### CURRENT EXISTING 2ND BUILDING DEPARTMENT SUBMITTAL SET

#### BUILDING TYPE 500 | Slab Edge & 1st Floor Plan Composite

© 2019 WILLIAM HEZMALHALCH ARCHITECTS, INC. DBA WHA. | 2017223 | 09-06-19

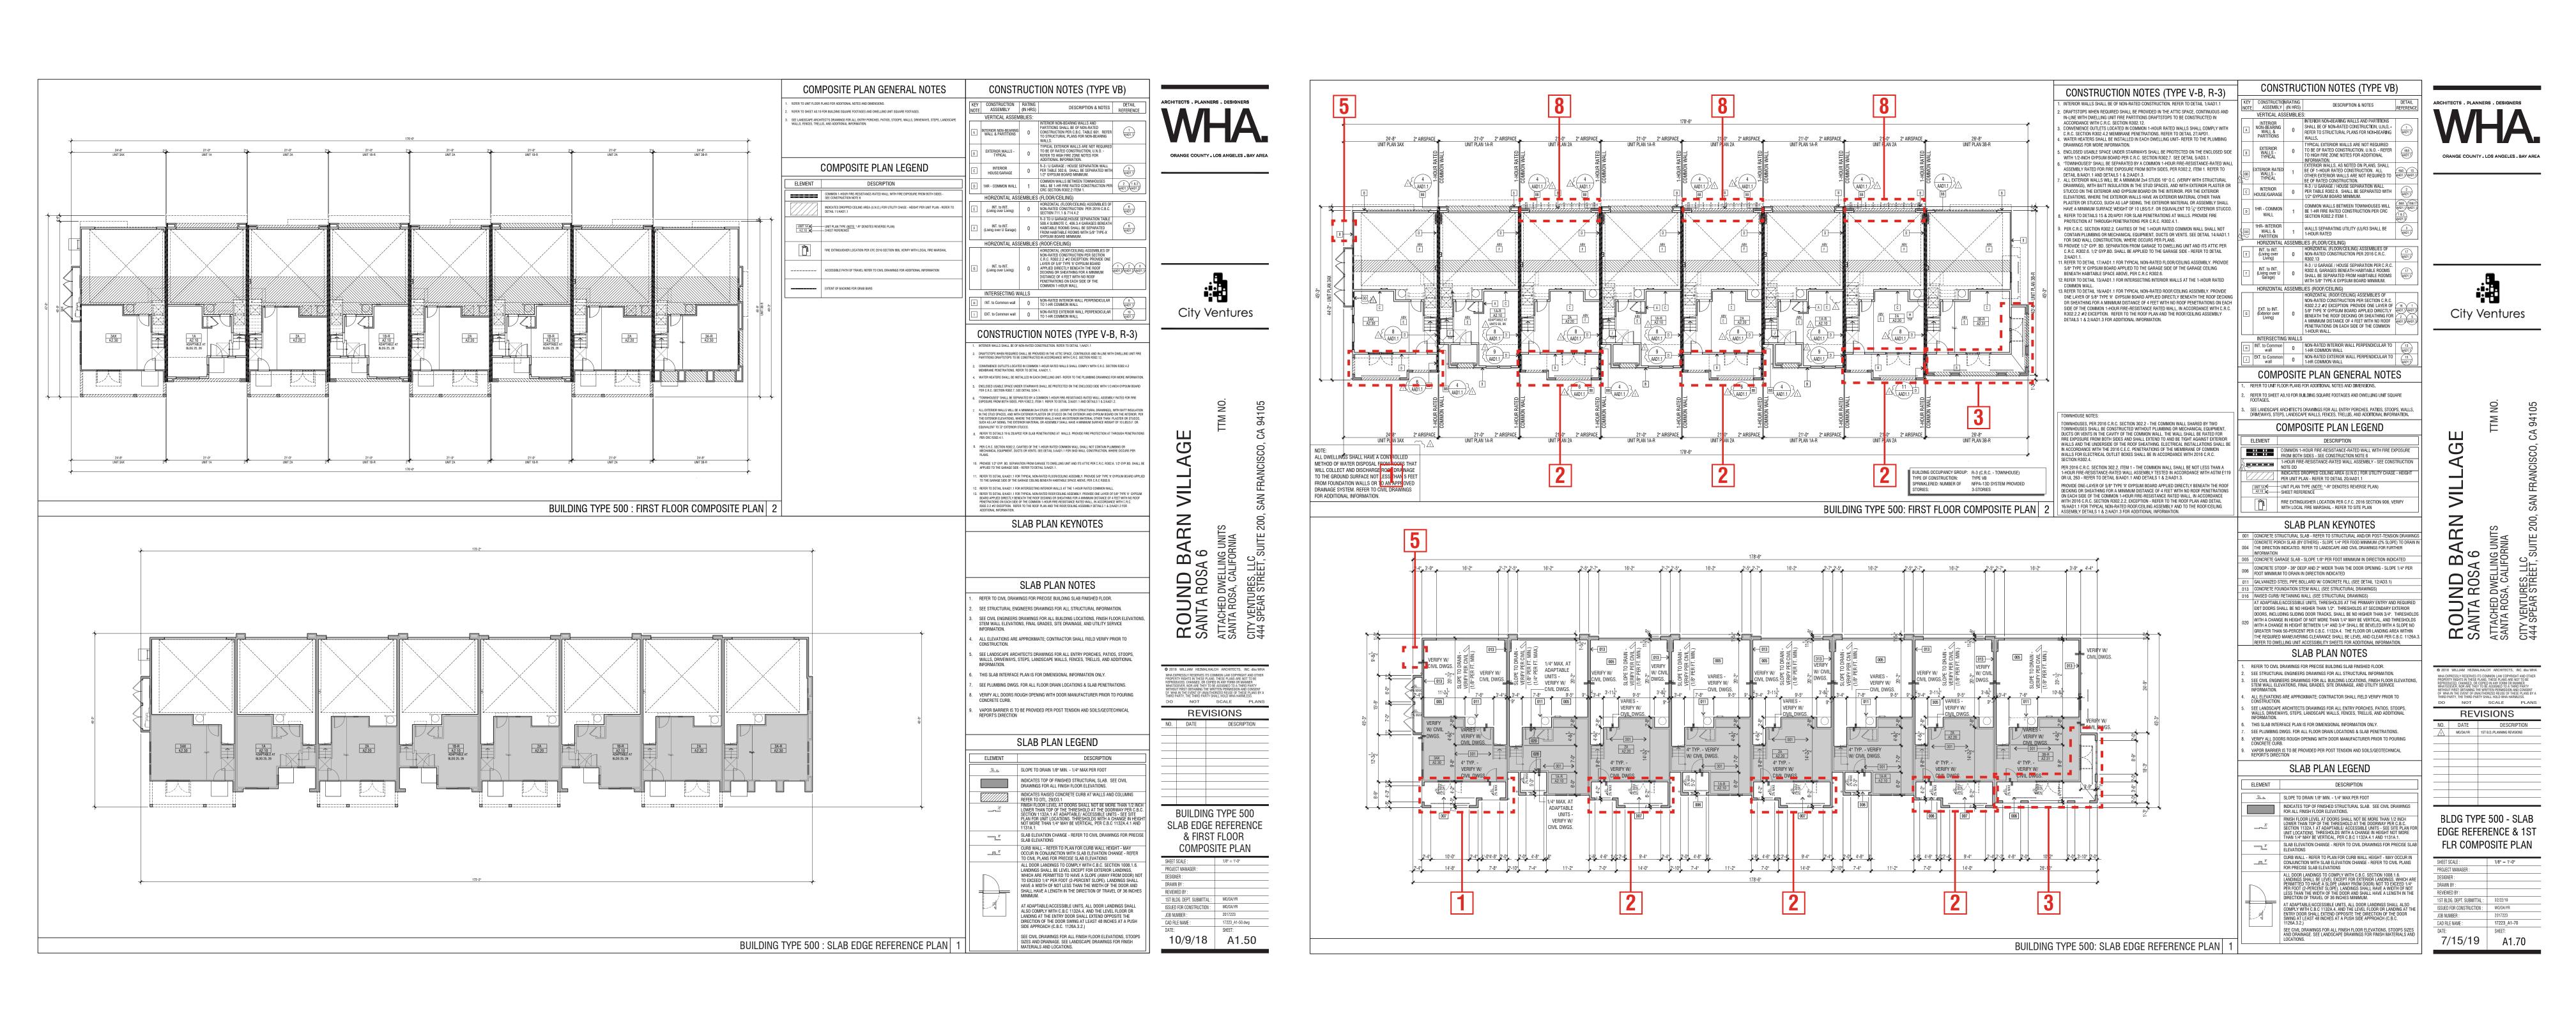
- 1 Unit 3A Added Covered Deck | Created Double Gable | Reconfigured Windows | Removed Awnings Above Windows | Removed / Replaced Horizontal Siding with Boards & Batts.
- 2 Unit 2A Added Covered Deck | Created Double Gable | Reconfigured Windows | Removed Awnings Above Windows | Removed / Replaced Horizontal Siding with Boards & Batts.
- 3 Unit 3B Added Wrap Around Deck / Reconfigured Porch | Added 3050 Window | Added Awning Above Deck Door and Windows at second level
- 4 Added Gable/Sloped Roof
- 5 Removed Ladder
- 6 Revised Second Floor Massing at Kitchen
- 7 Added Awning
- 8 Added Trellis at Unit 2A, Typ.

#### BUILDING TYPE 500 | 2nd & 3rd Floor Plan Composite

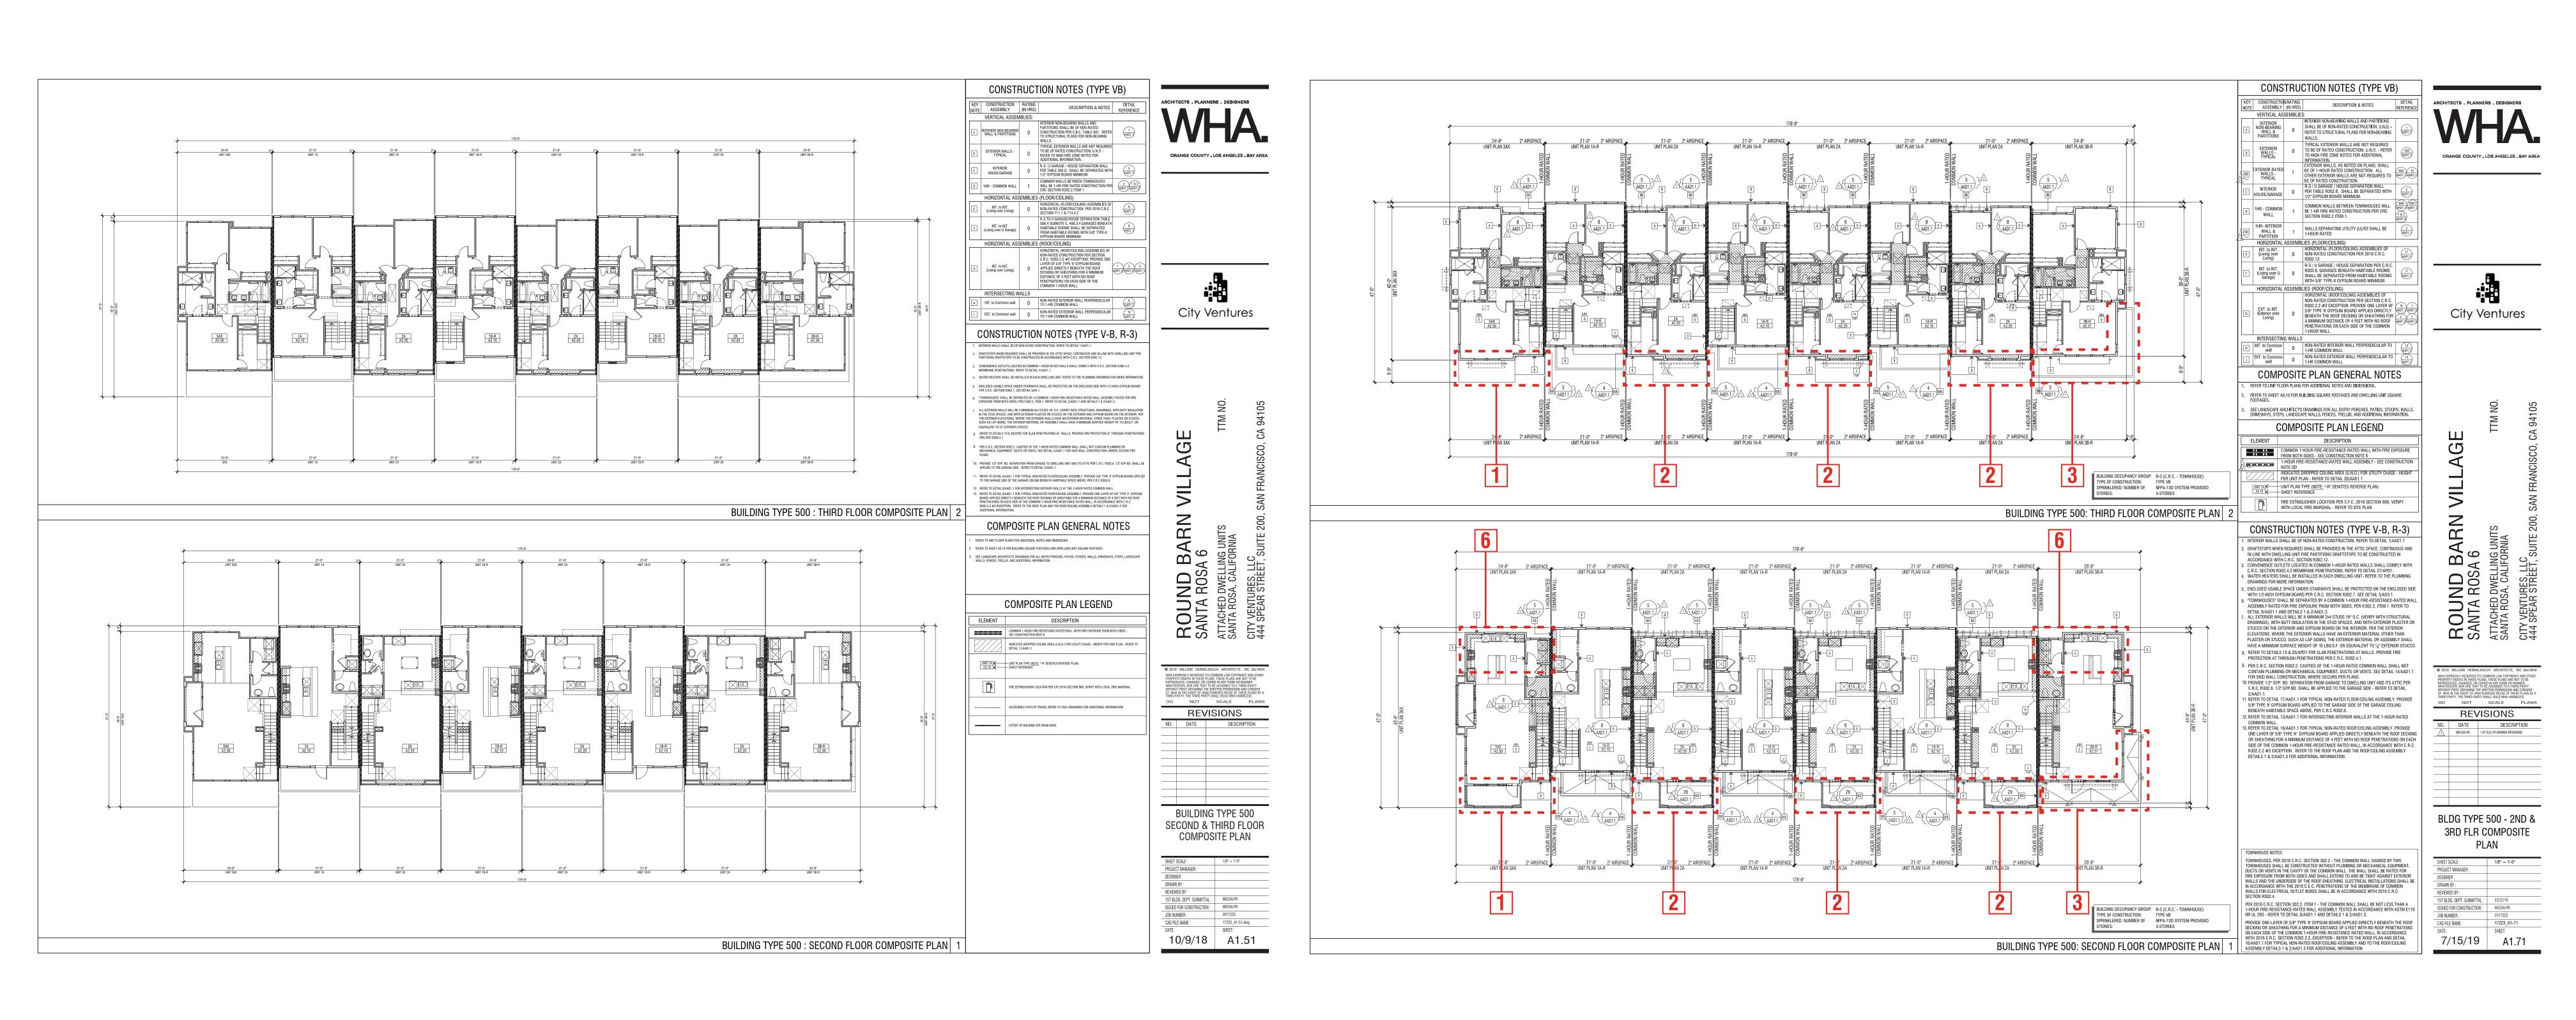
- 1 Unit 3A Added Covered Deck | Created Double Gable | Reconfigured Windows | Removed Awnings Above Windows | Removed / Replaced Horizontal Siding with Boards & Batts.
- 2 Unit 2A Added Covered Deck | Created Double Gable | Reconfigured Windows | Removed Awnings Above Windows | Removed / Replaced Horizontal Siding with Boards & Batts.
- 3 Unit 3B Added Wrap Around Deck / Reconfigured Porch | Added 3050 Window | Added Awning Above Deck Door and Windows at second level
- 4 Added Gable/Sloped Roof
- 5 Removed Ladder
- 6 Revised Second Floor Massing at Kitchen
- 7 Added Awning
- 8 Added Trellis at Unit 2A, Typ.

**BUILDING TYPE 500 | Roof Plan**

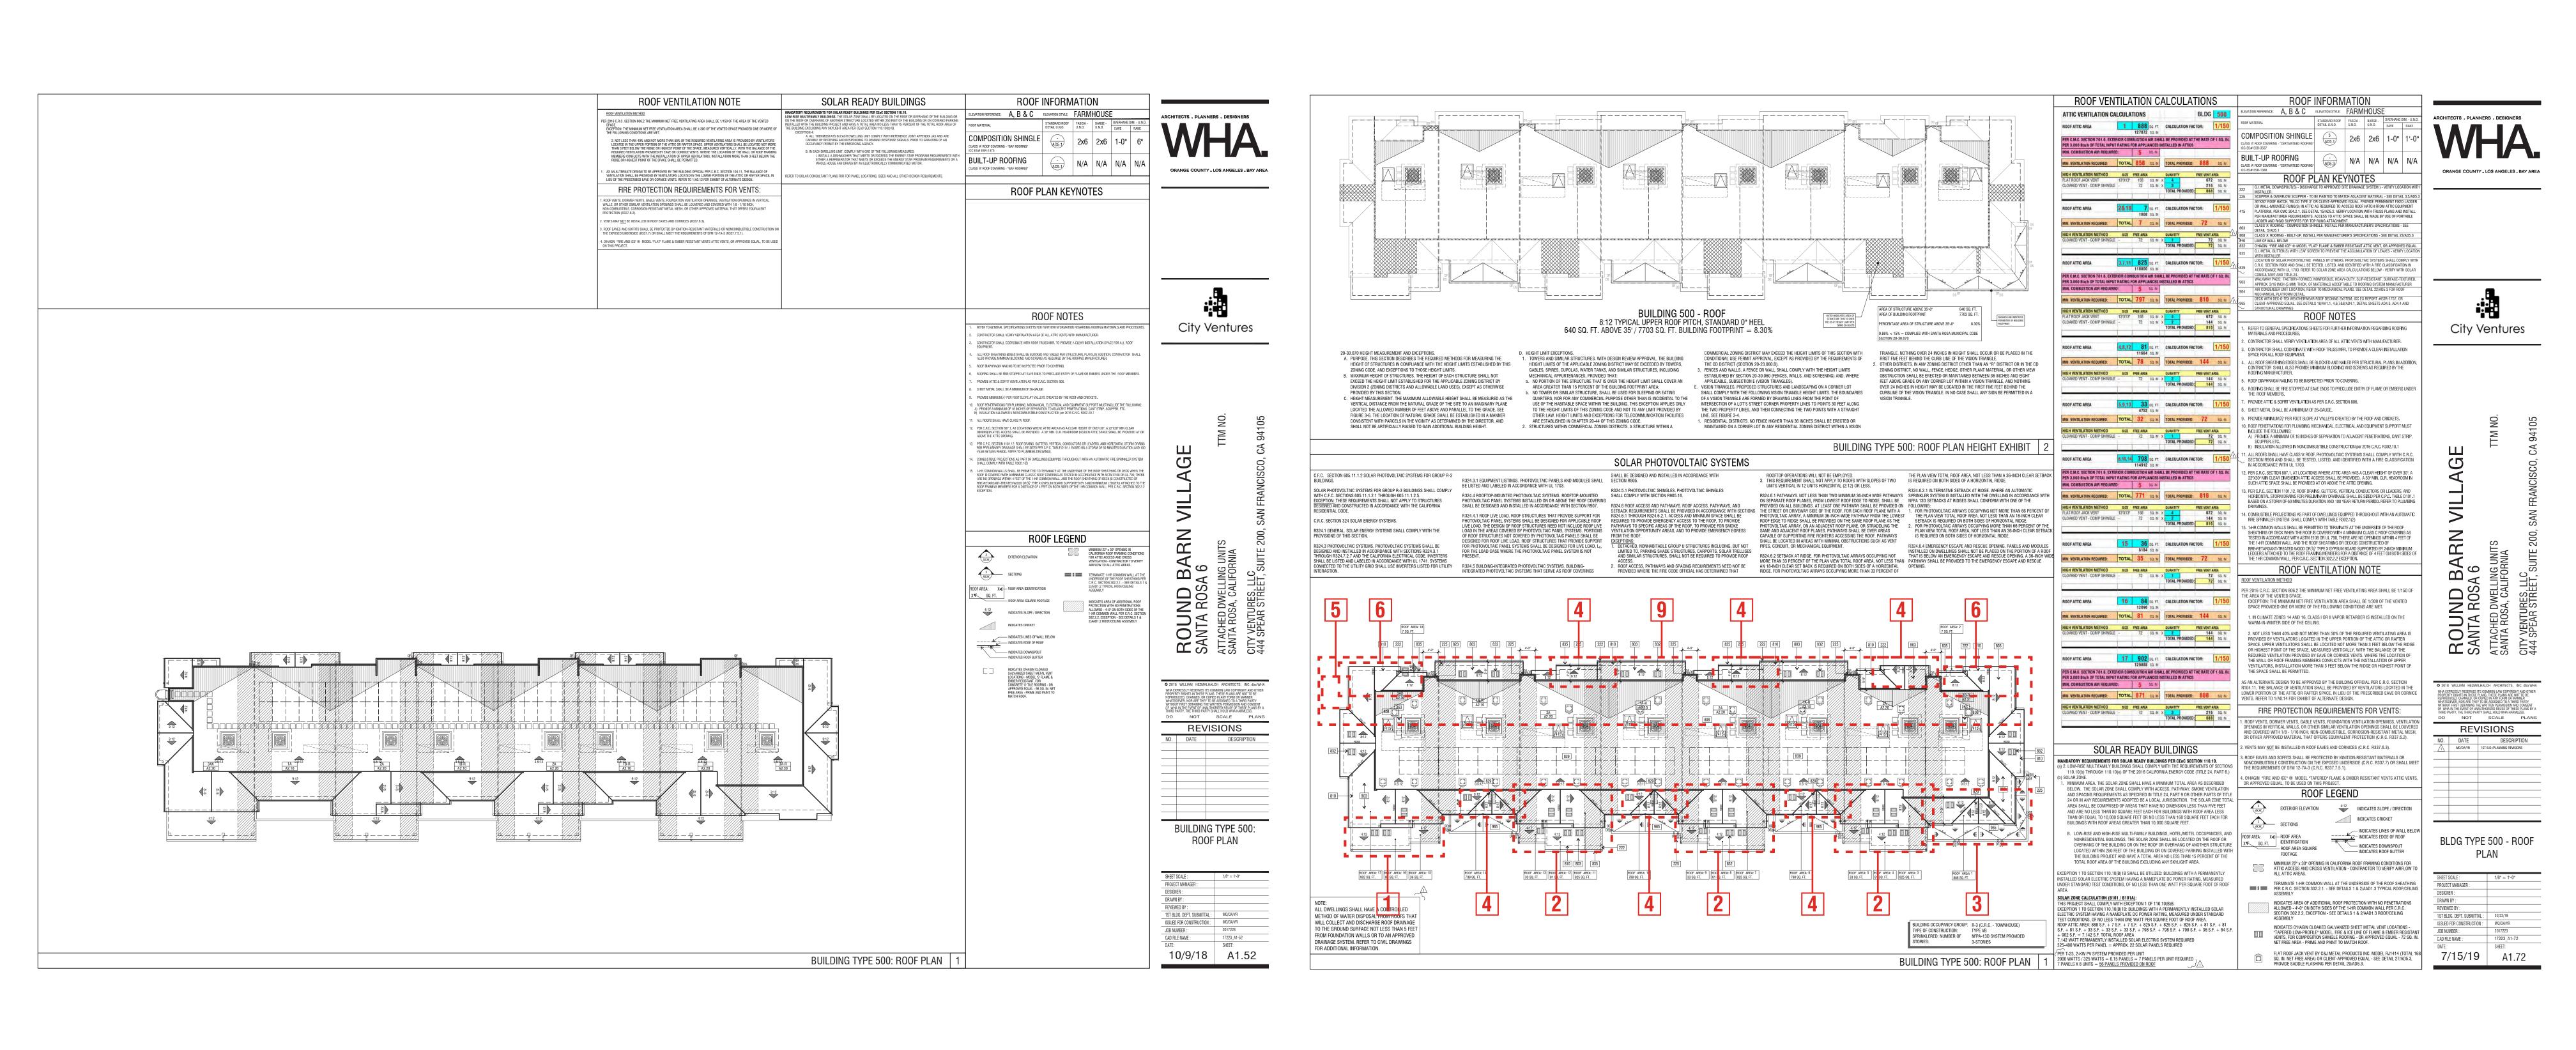
- 1 Unit 3A Added Covered Deck | Created Double Gable | Reconfigured Windows | Removed Awnings Above Windows | Removed / Replaced Horizontal Siding with Boards & Batts.
- 2 Unit 2A Added Covered Deck | Created Double Gable | Reconfigured Windows | Removed Awnings Above Windows | Removed / Replaced Horizontal Siding with Boards & Batts.
- 3 Unit 3B Added Wrap Around Deck / Reconfigured Porch | Added 3050 Window | Added Awning Above Deck Door and Windows at second level
- 4 Added Gable/Sloped Roof
- **5** Removed Ladder
- 6 Revised Second Floor Massing at Kitchen
- 7 Added Awning
- 8 Added Trellis at Unit 2A, Typ.

9 Per City Fire Request The Rear Elevation Roof Design Has Been Modified

#### **BUILDING TYPE 500 | Style 1 Exterior Elevations**

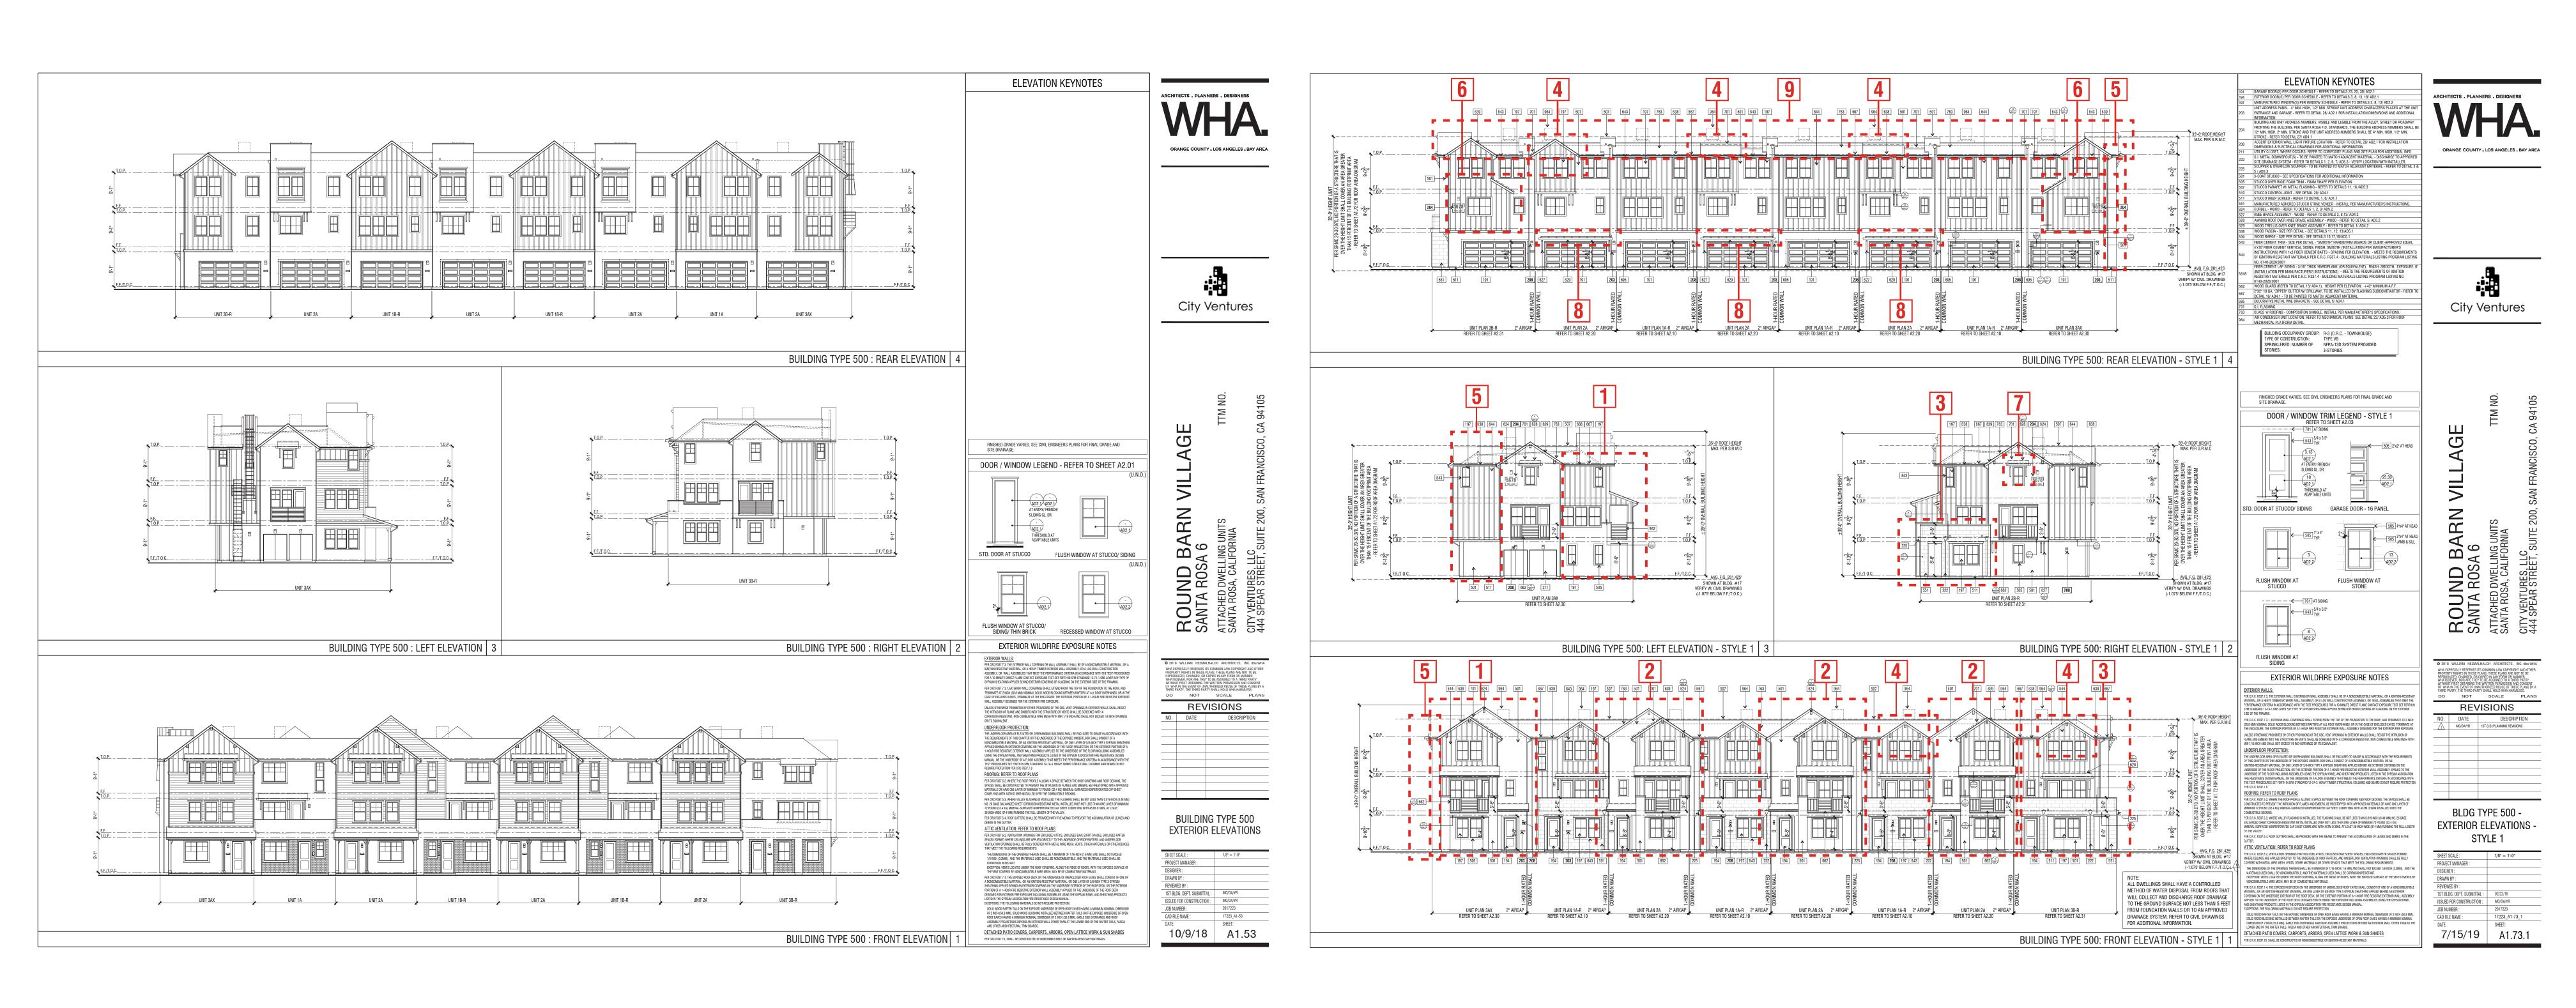
- 1 Unit 3A Added Covered Deck | Created Double Gable | Reconfigured Windows | Removed Awnings Above Windows | Removed / Replaced Horizontal Siding with Boards & Batts.
- 2 Unit 2A Added Covered Deck | Created Double Gable | Reconfigured Windows | Removed Awnings Above Windows | Removed / Replaced Horizontal Siding with Boards & Batts.
- 3 Unit 3B Added Wrap Around Deck / Reconfigured Porch | Added 3050 Window | Added Awning Above Deck Door and Windows at second level
- 4 Added Gable/Sloped Roof
- 5 Removed Ladder
- 6 Revised Second Floor Massing at Kitchen
- 7 Added Awning

8 Added Trellis at Unit 2A, Typ.

9 Per City Fire Request The Rear Elevation Roof Design Has Been Modified
